ORIGINATION FORM

Proposed Revisions to a Standard Plans Index

Index Number: 715-002

Index Title: Standard Aluminum Lighting

ELEVATIONS

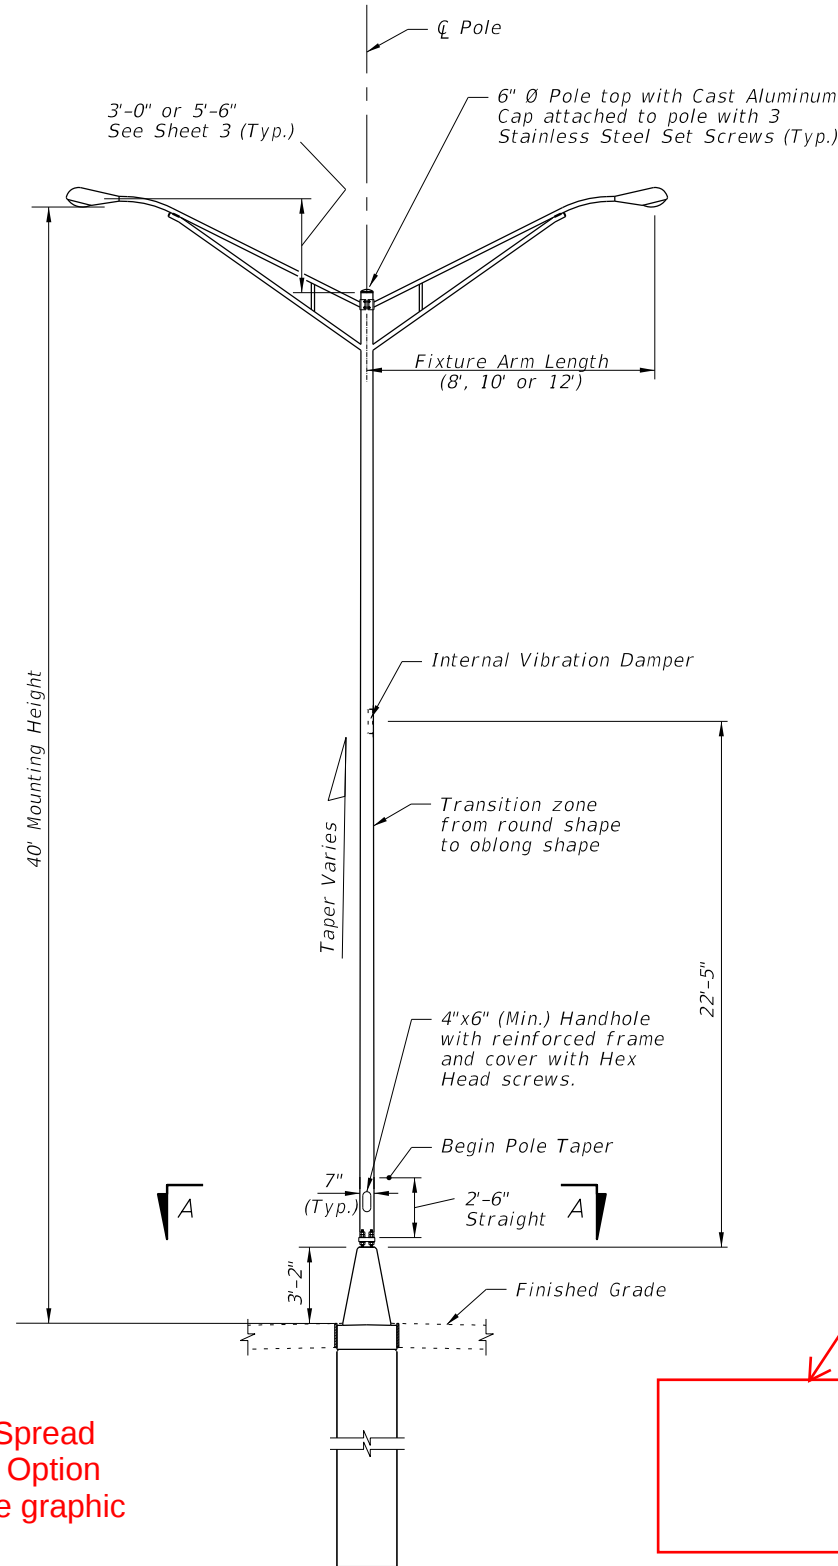
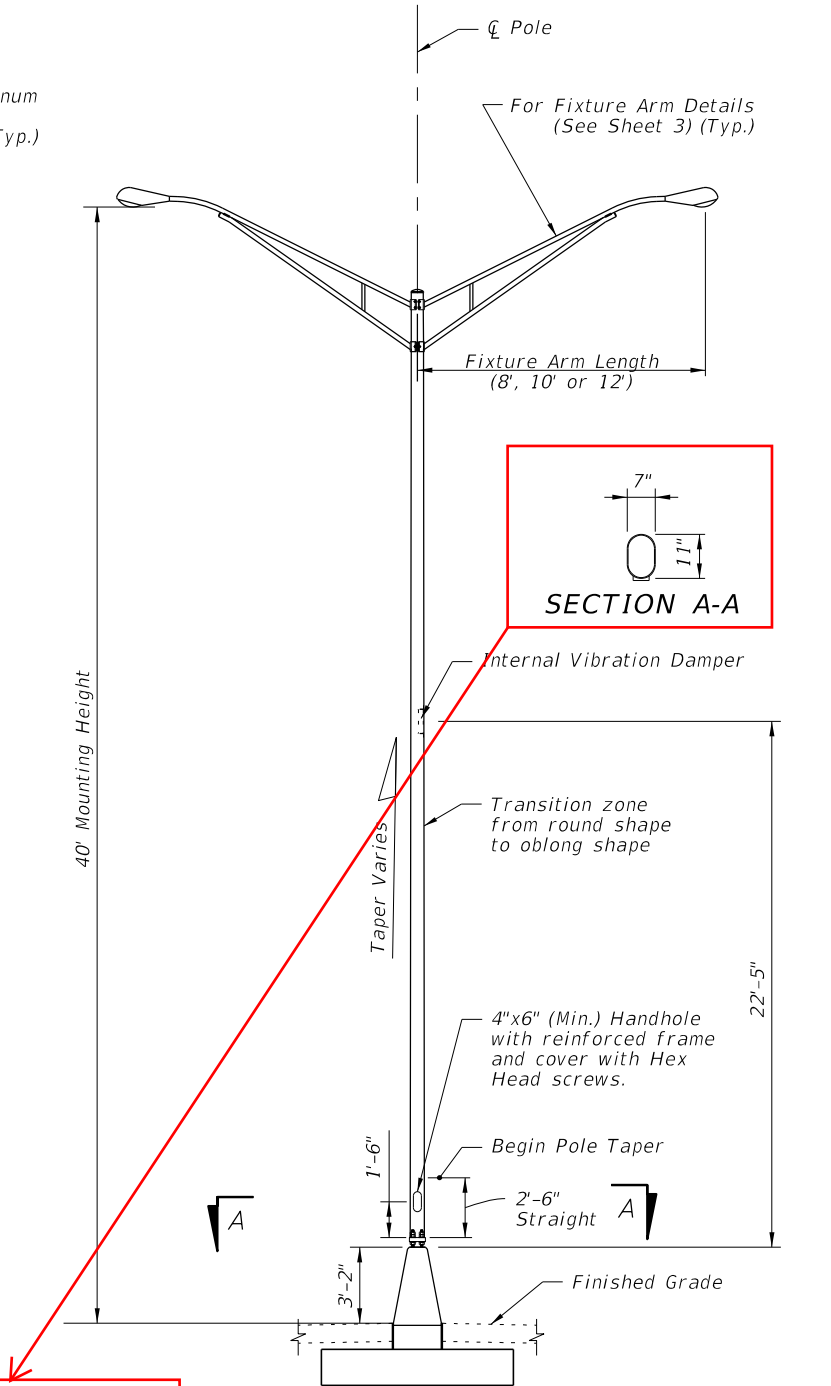
Sheet 2: Added a spread footing example in elevation details; Changed elevation titles to explain shaft footing option and new spread footing option; Added callout and Index 522-001 reference for cold joint connection between spread footing and raised curb

(Shaft Foundation Option Shown, Spread Footing Foundation Option Similar)

Added parenthesis descriptions for foundations

(Spread Footing Foundation Option Shown, Shaft Foundation Option Similar)

moved SECTION A-A for higher visibility

SHAFT FOUNDATION OPTION WITH LIGHT POLE & BASE DETAILS

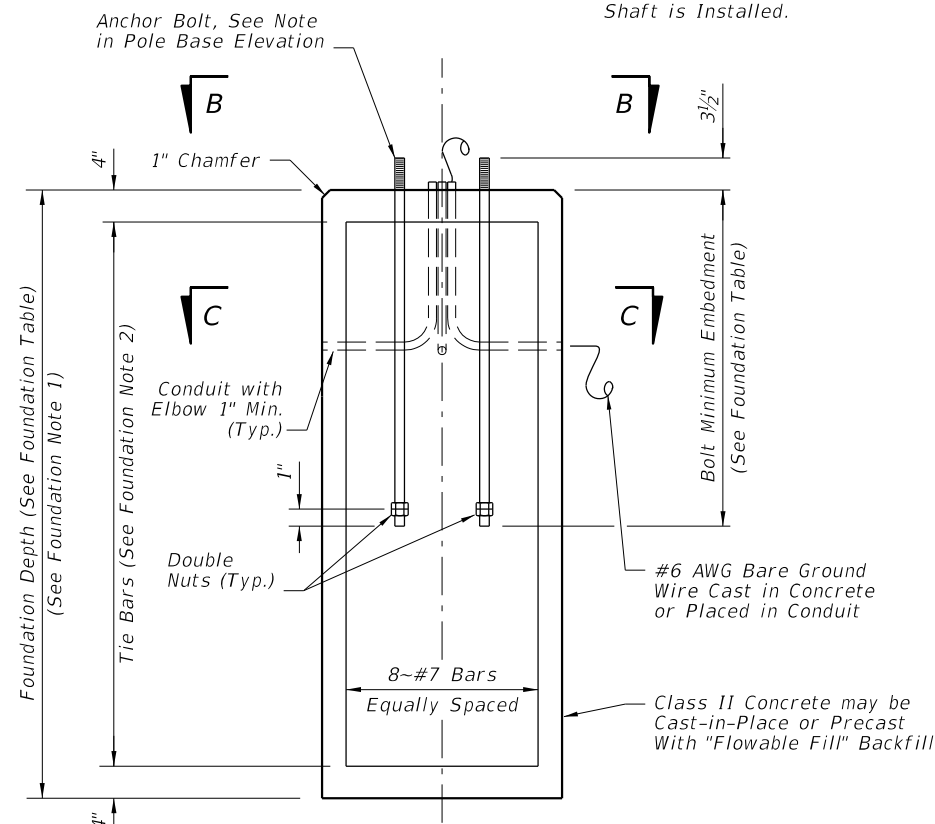
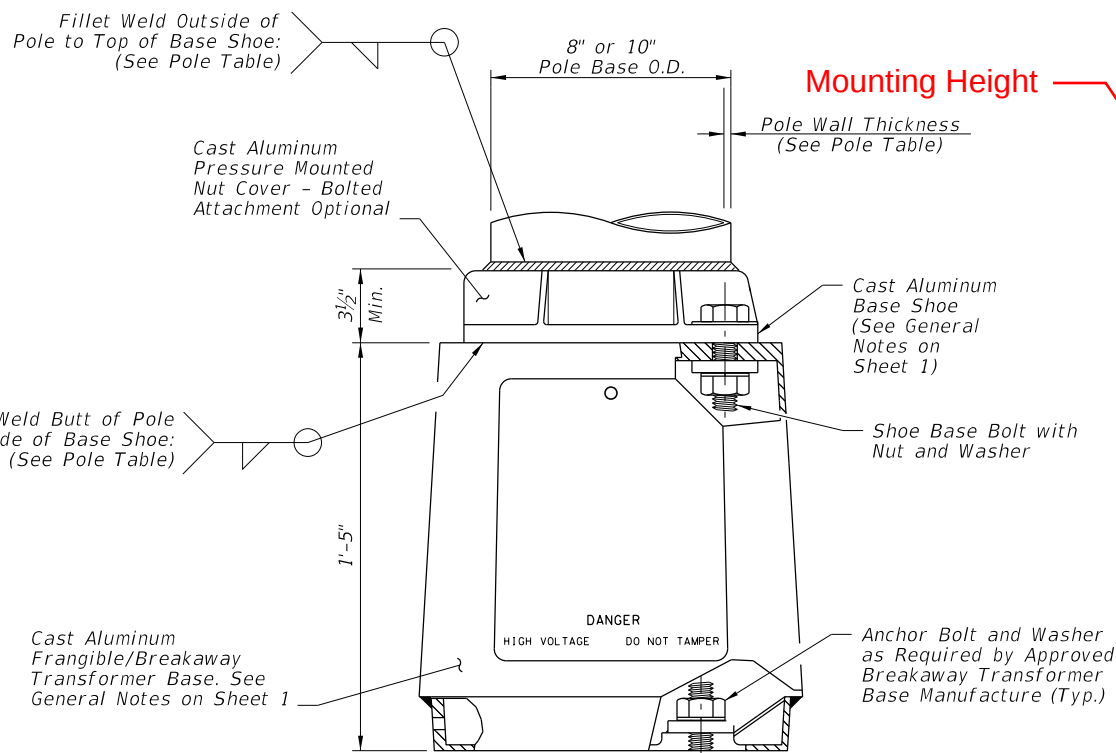
Sheet 4: Changed sheet title to "Shaft Foundation Option with Light Pole & Base Details"; Changed table and elevation detail titles from "Foundation" to "Shaft Foundation". Within Tables, changed "Assembly Height" to "Mounting Height" for consistency with SPI and FDM.

BASE PLATE DETAILS FOR MEDIAN BARRIER MOUNTED ALUMINUM LIGHT POLE

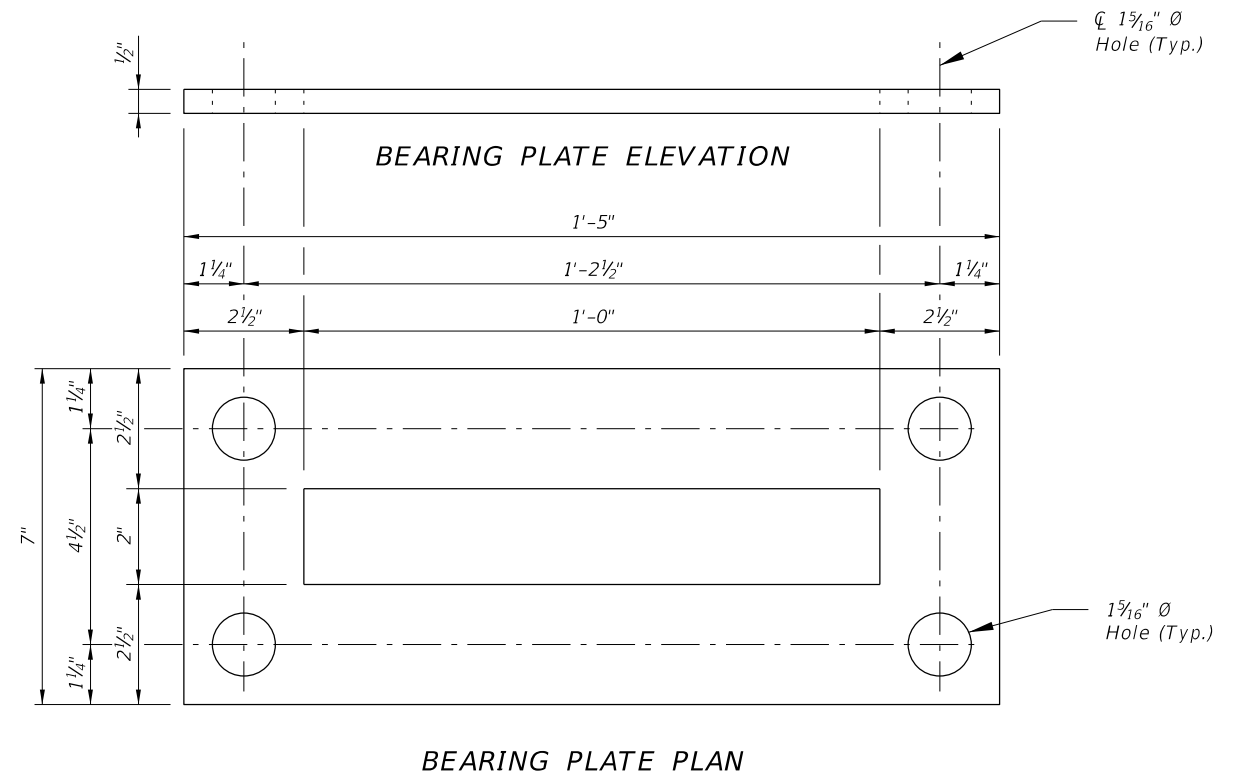
1. For locations of Bearing Plates, Base Plates and Detail 'A' see Sheets ~~6 & 7~~ **7 thru 9**.
2. Double Nuts: The bottom hex nut may be substituted by a half-height 'jam' nut.
3. Provide individual nut covers (not shown) for each bolt.
4. Pole wall thicknesses shown are nominal and shall be within the Aluminum Association Tolerances. Thicker walls are permitted and tapered walls may be used in accordance with the minimum Aluminum Association thicknesses.

SPREAD FOOTING DETAILS FOR MEDIAN BARRIER MOUNTED ALUMINUM LIGHT POLE

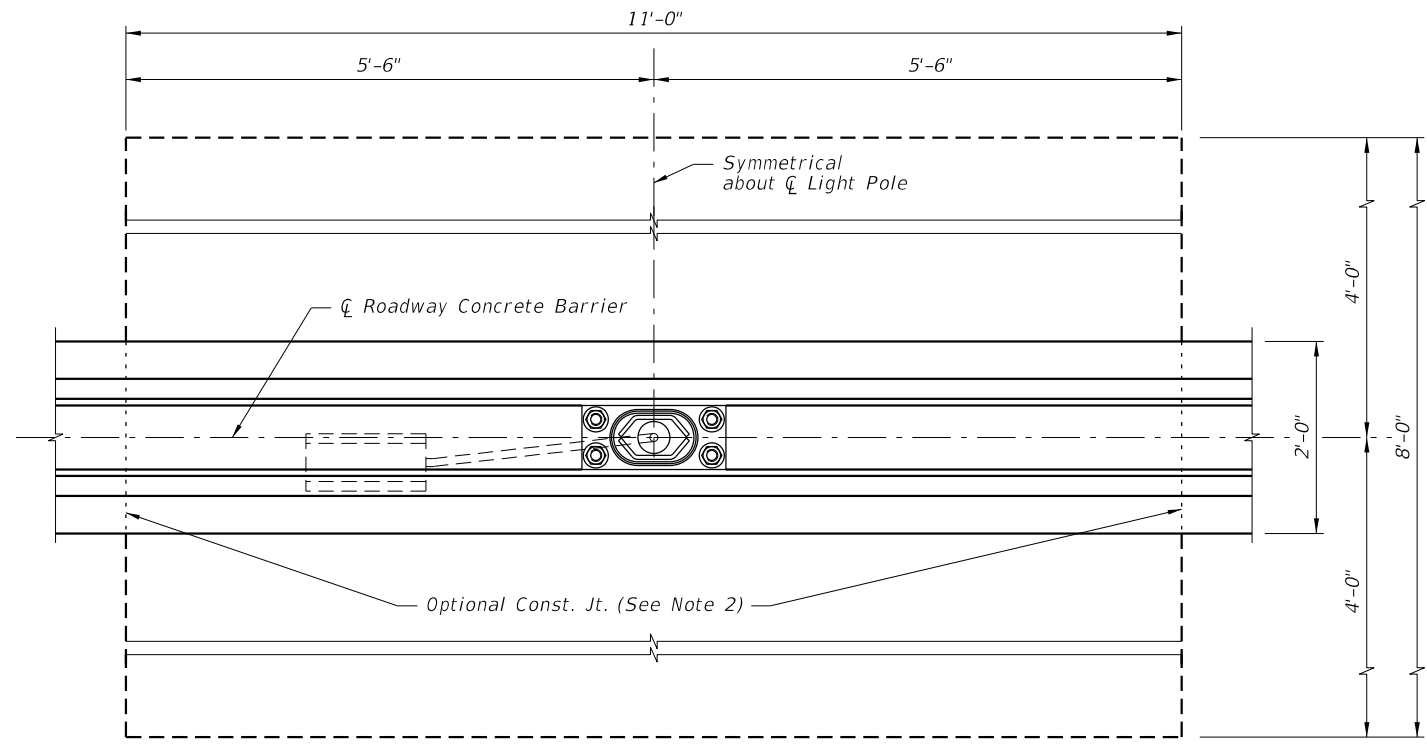
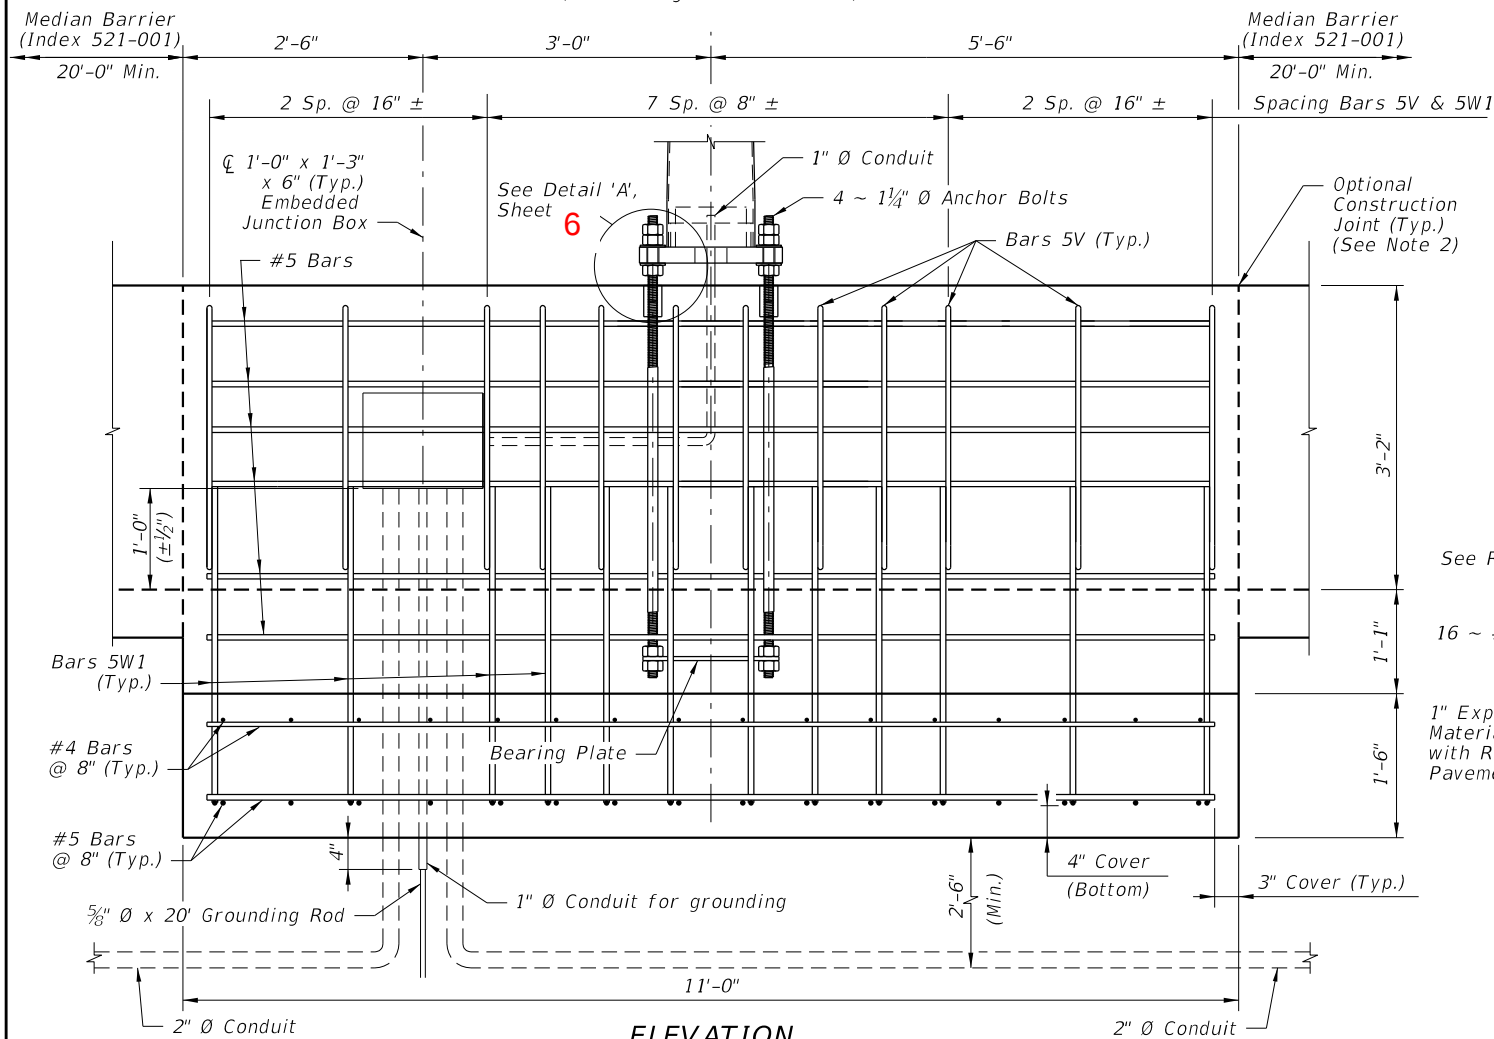
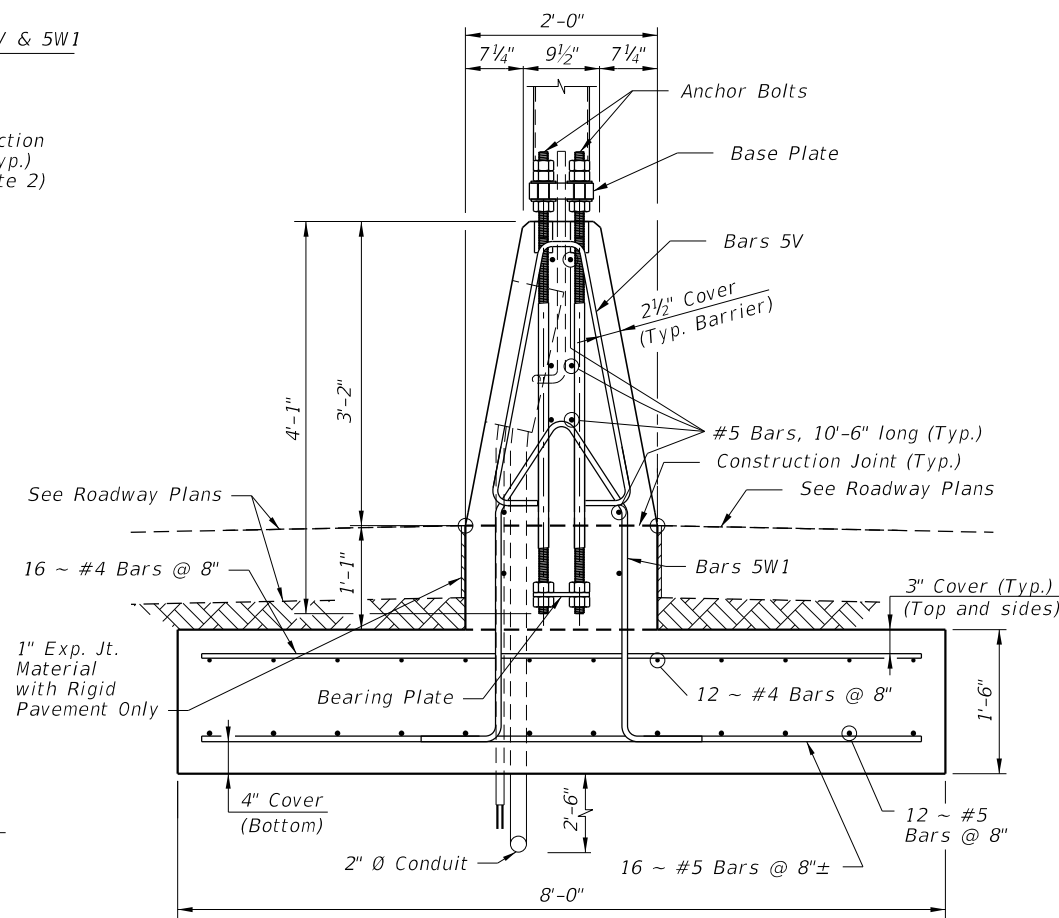
1. For Bearing Plate and Base Plate Details, see Sheet 5 **Sheet 6**
2. For connections to adjacent Median Barrier, use the Doweled Joint detail per Index 521-001. Alternatively, a continuous concrete pour or a construction joint may be substituted; these alternatives require the Median Barrier's longitudinal steel to lap a minimum of 2'-0" with the longitudinal steel shown herein.
